UNITED STATES
DEPARTMENT OF THE INTERIOR
BUREAU OF LAND MANAGEMENT
SUNDRY NOTICES AND REPORTS ON WELLS

8. Well Name and No.
Laguna Salado 22 Federal 5H

9. API Well No.
30-015-36738

**Laguna Salado 22 Federal 5H
30-015-36738
Devon Energy Production Company, LP
November 19, 2008
Conditions of Approval**

M 41 Choke hose

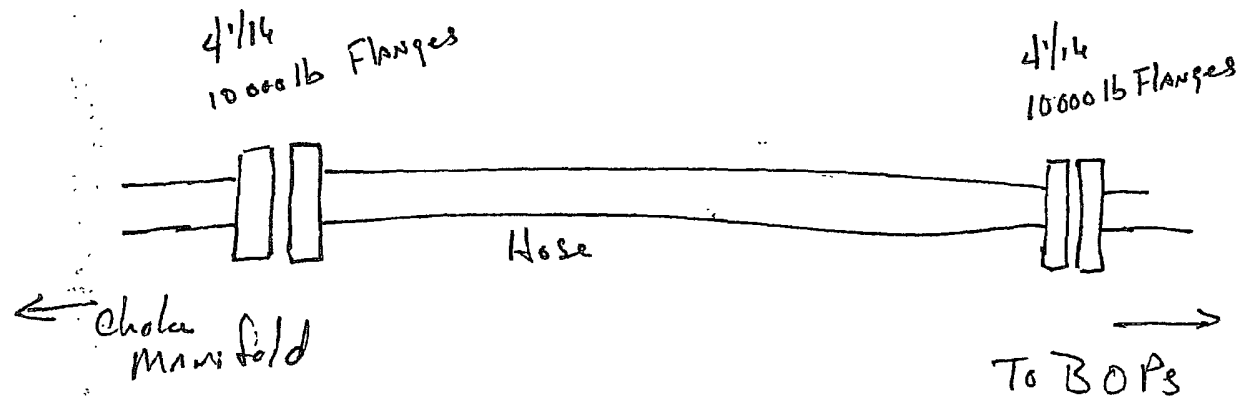
Devon Energy Production Company L. P. respectfully requests to change from the McVay Drilling Rig No. 6 to Nabors Pace #M41 to drill this well and requests a variance that a co-flex hose may be used between the BOP and the choke manifold. The hose will be kept as straight as possible with minimal turns. **CO-Flex Hose Manufacturer: Phoenix Beattie; approximately 22' (7.62 meters) of co-flex line; 3" coupling w/ 4 1 1/16" flanges on each end - 10,000 psi; Quality Control Inspection & Test Certificate attached; see configuration schematic. Safety clamps are not required since the ends are flanged.**

- 1. Variance approved to use flex line from BOP to choke manifold. Check condition of 4-1/16" flexible line from BOP to choke manifold, replace if exterior is damaged or if line fails test. Line to be as straight as possible with no hard bends.**
